Flight Procedures Cover Page	Task Action: FLIGHT CHECK	Task Type: STAR	Estimated Chart Date: 05/16/2024	APWS Task ID: EE3B877A78F54C3EAA72CE039ACAC1A6	APWS Project ID: F40C4B0DFFA04E6E834962AAE034ADB4
Procedure: SPANE EIGHT ARRIVAL		Enroute: YES	Specialist: Prassada, Parnell		Agreement Number:
Airport ID: KSLC			Airport City: SALT LAKE CITY		State: UT
Facility ID:	Facility Type:	Flight Inspection Remark Type: New FC Slot

FC: MOCA VALUES ADDED AND MEEKER (EKR) VOR/DME; MAGVAR CHANGED FROM E15°/1969 TO E9°/2020.

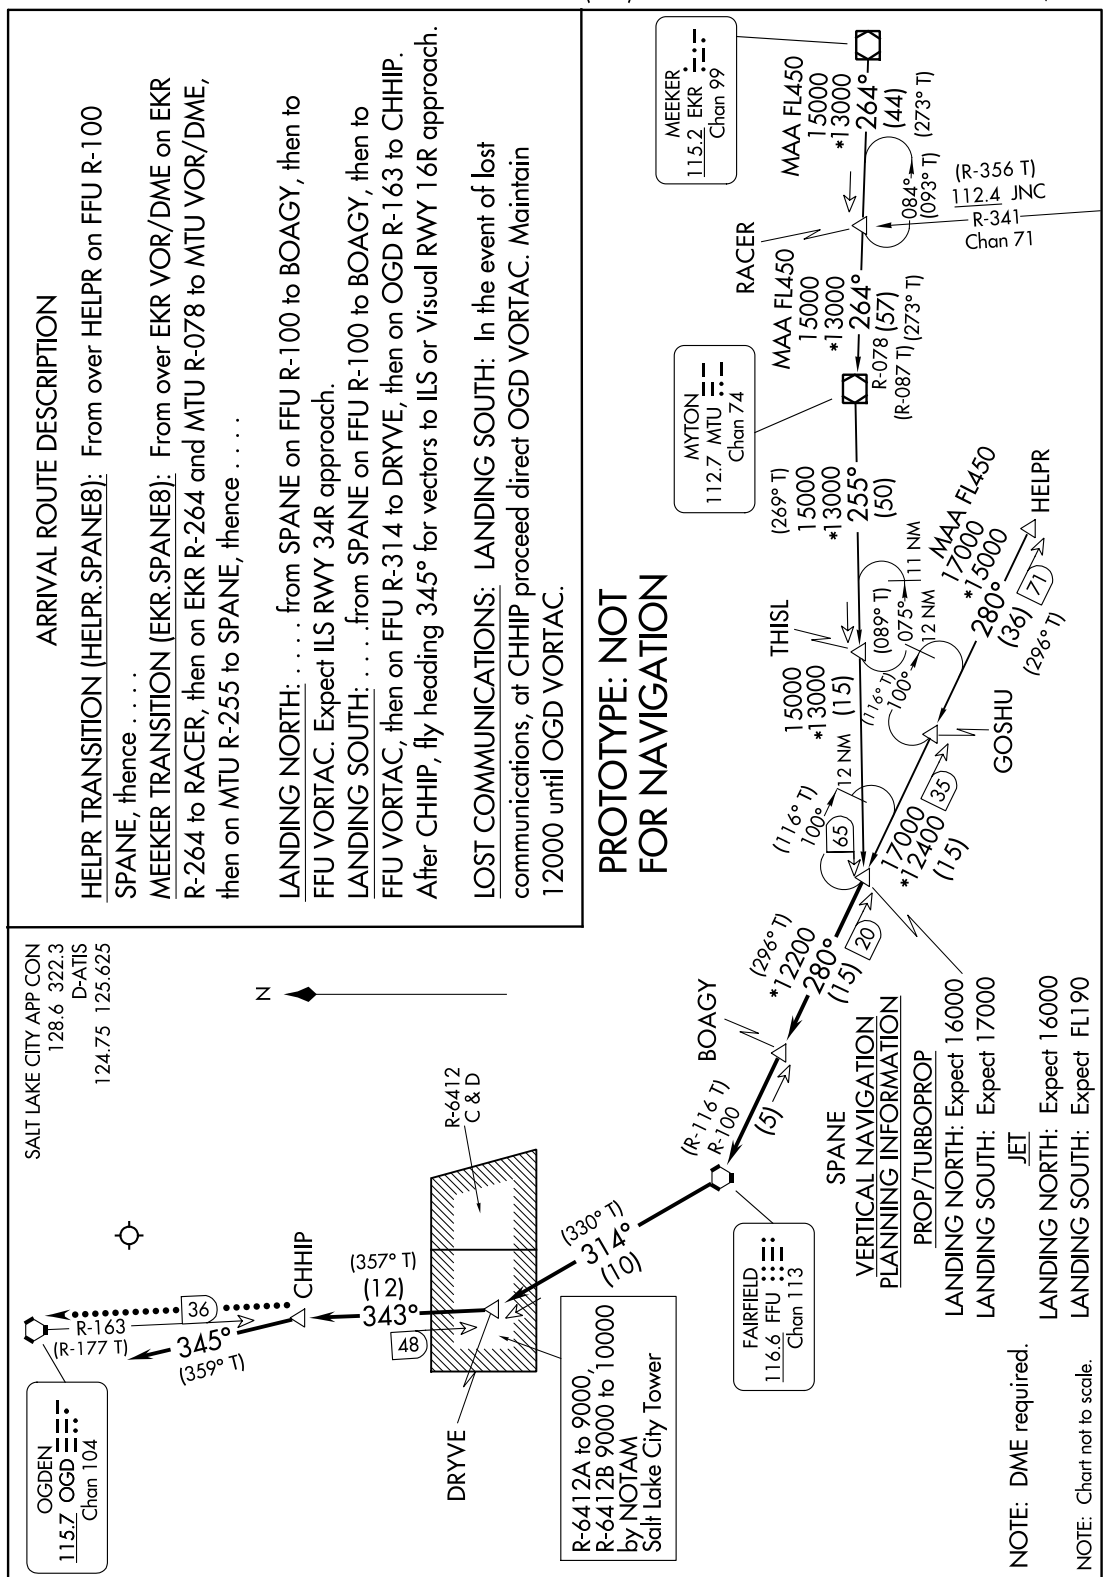
8260-2 SPANE
04/05/2024: THIS IS A CORRECTED COPY OF THE FORM APPROVED ON 01/08/2024.
1. REMARKS: ADDED "FAIRFIELD (FAC 1) AND MYTON (FAC 2) USED TO ESTABLISH FIX COORDINATES."
2. FIX USE: ADDED FAC 1, 2 TO SPANE AT KSLC.
